## COMPREHENSIVE MONITORING PROGRAM

### FINAL TECHNICAL PLAN

Version 3.2

GROUND WATER

### FIGURE 1.1-2

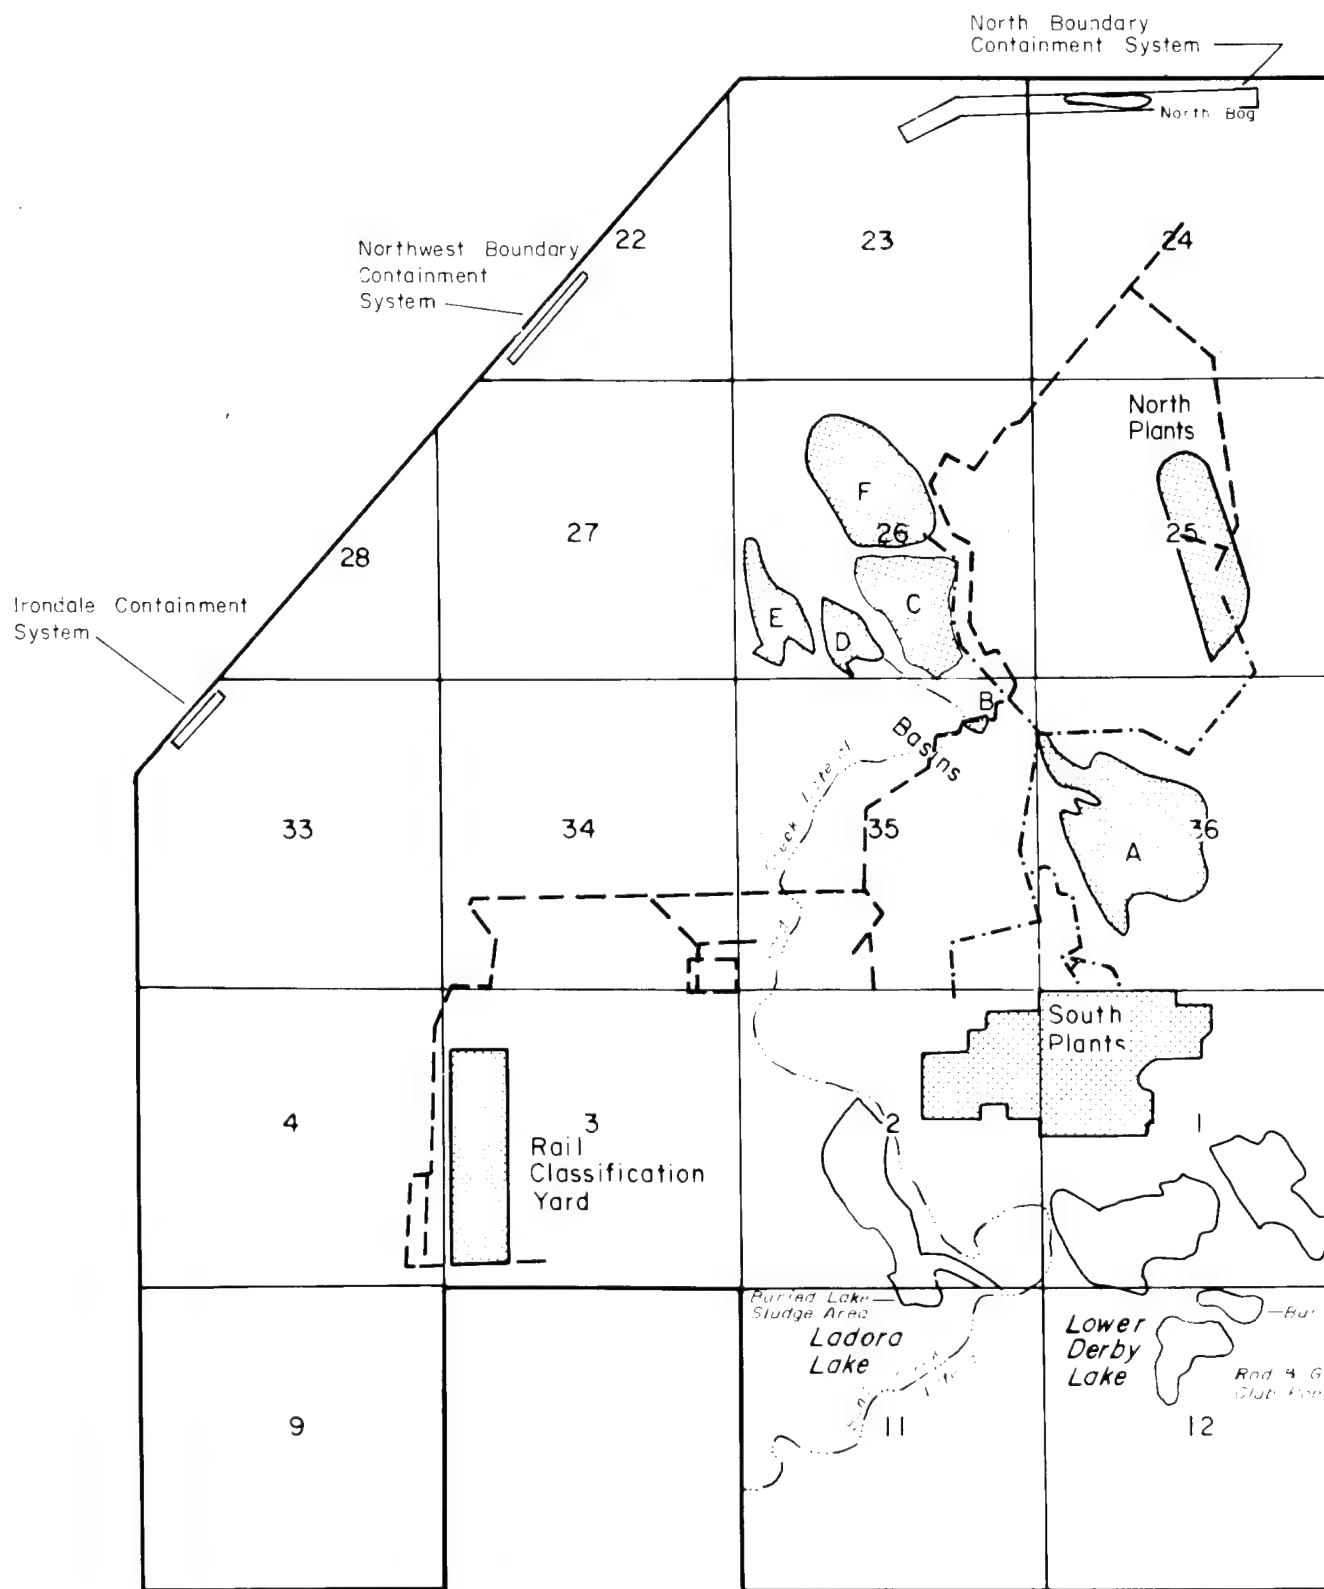
For consistency with the second full paragraph on page 3, solid waste disposal areas and the chemical sewer system should be shown in Figure 1.1-2.

**Response:** Figure 1.1-2 will be revised accordingly.

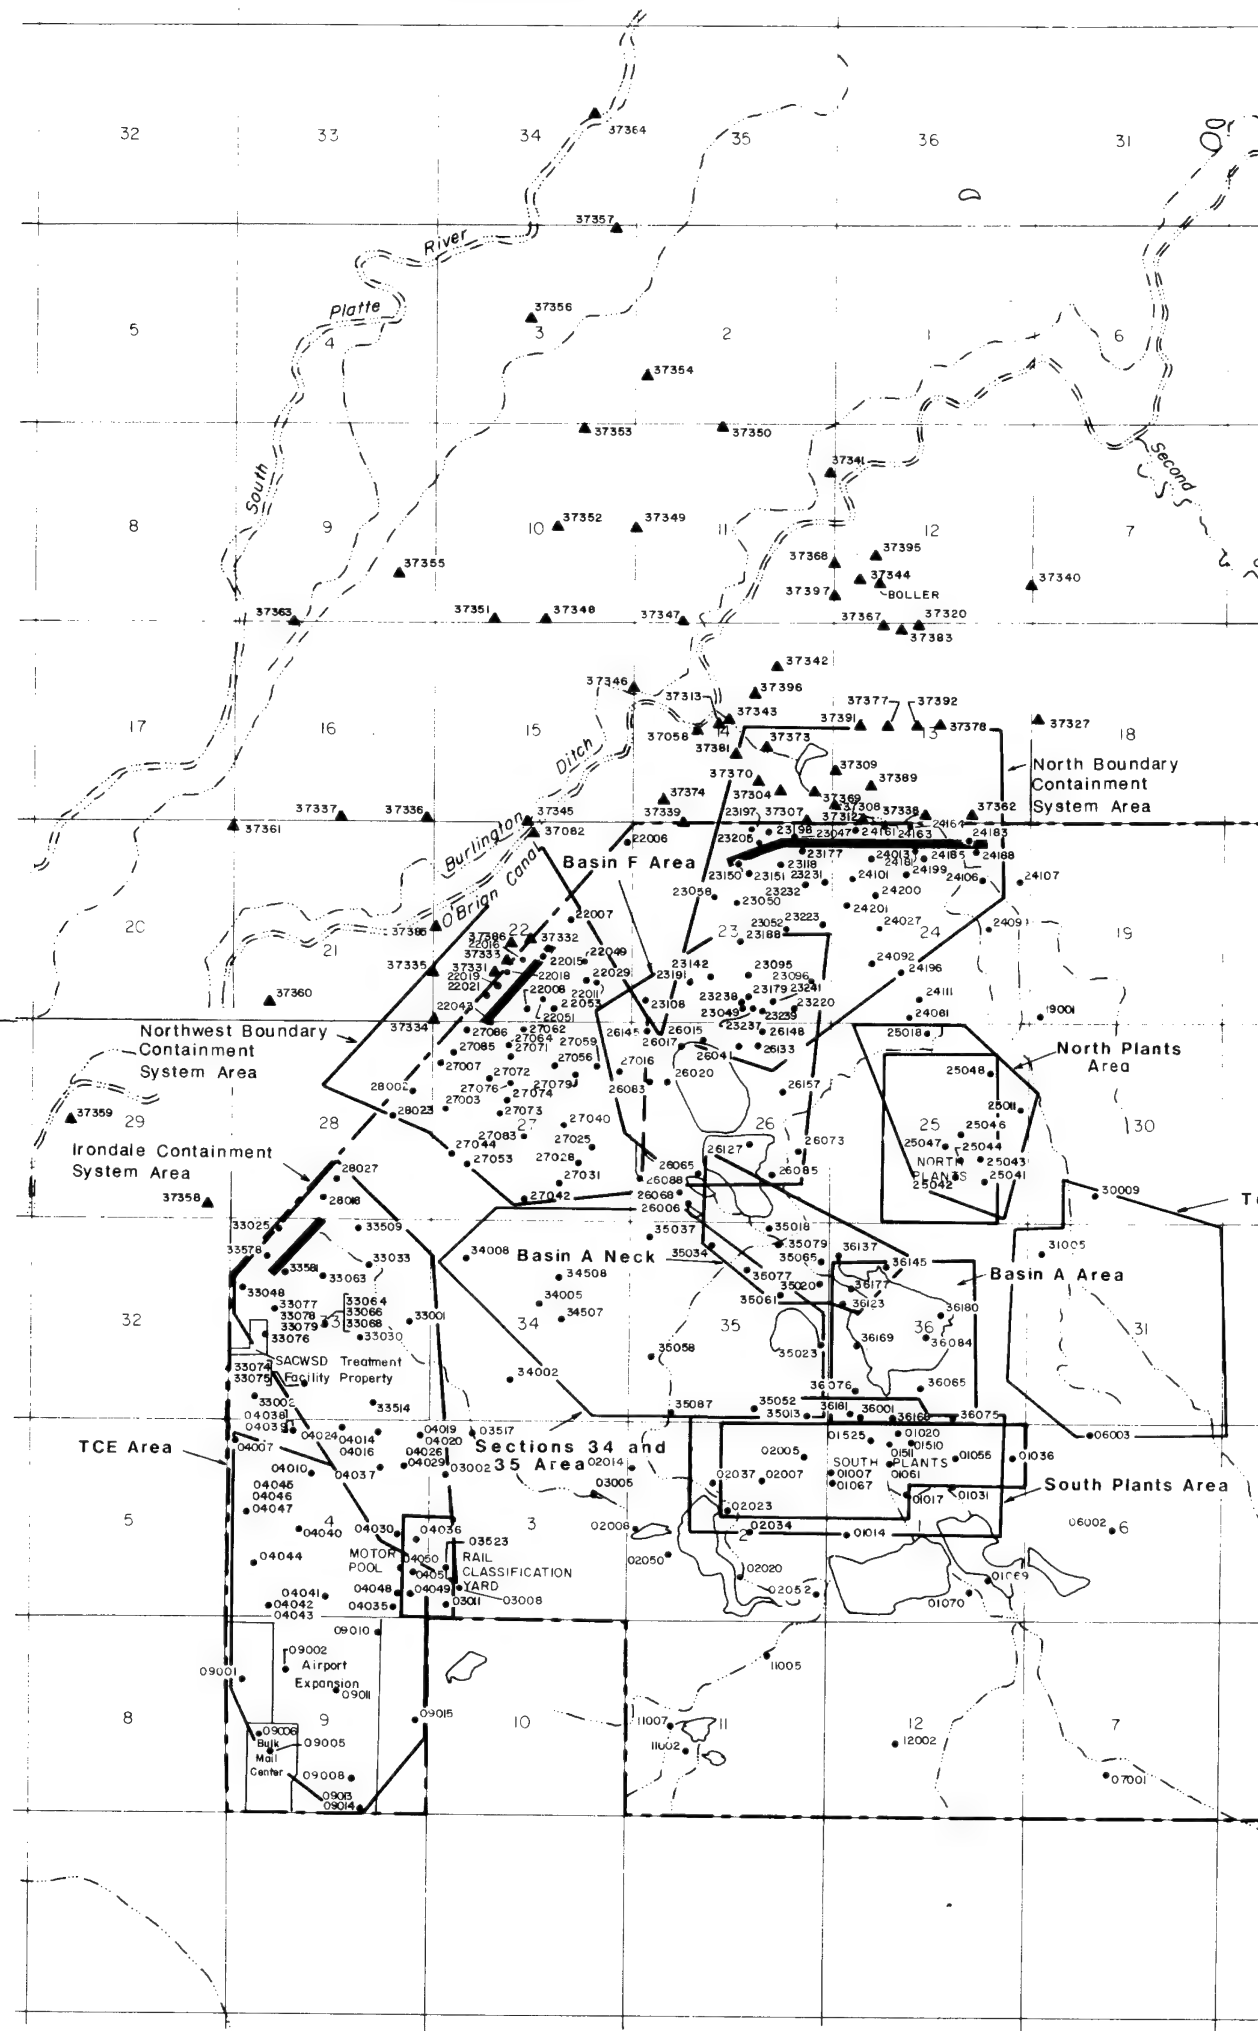
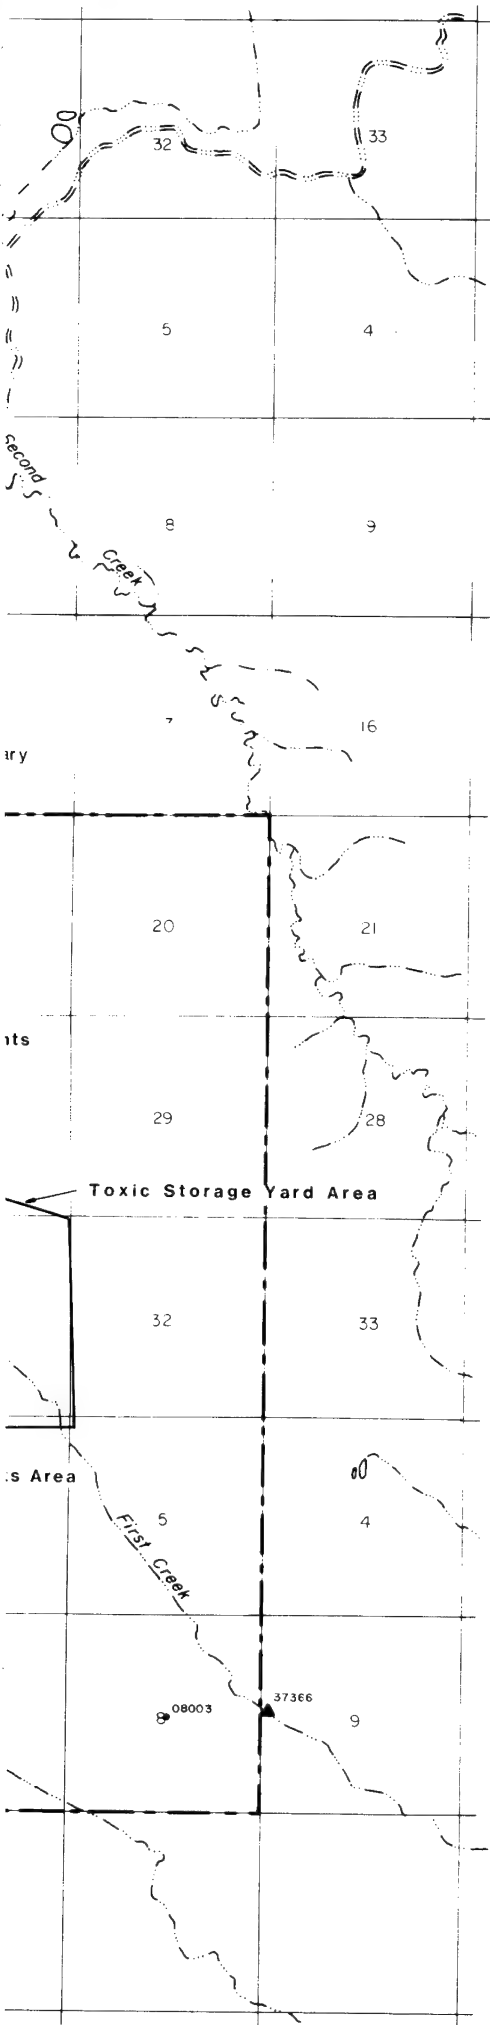
**Comment 13.** **Pgs. 46-51 and Plates 2.3-1 and 2.3-2** - All additional wells to be included in the program should be added to the appropriate lists and Plates. Well 24136 is missing from Plate 2.3-2. Well 26061 is included on Plate 2.3-2 but not on one of the lists.

**Comment 8:** Not all Denver formation wells listed in Table 2.3-4, show up on Plate 2.3-2. Well 37390 is not shown.

**Response:** The Draft Final CMP Technical Plan, Plates 2.3-1 and 2.3-2 present wells that comprise the annual monitoring-well network. The wells mentioned in the Plates for the semi-annual or quarterly monitoring-well networks were not included in this plan. Modifications to any of the monitoring networks will be reflected in revised lists and Plates. The errors identified have been noted.

**Response:** The wells presented on Plates 2.3-1 and 2.3-2 correspond to the wells listed in Table 2.4-1. These wells comprise the CMP annual sampling event. Wells sampled semi-annually and quarterly are included within the annual well network.
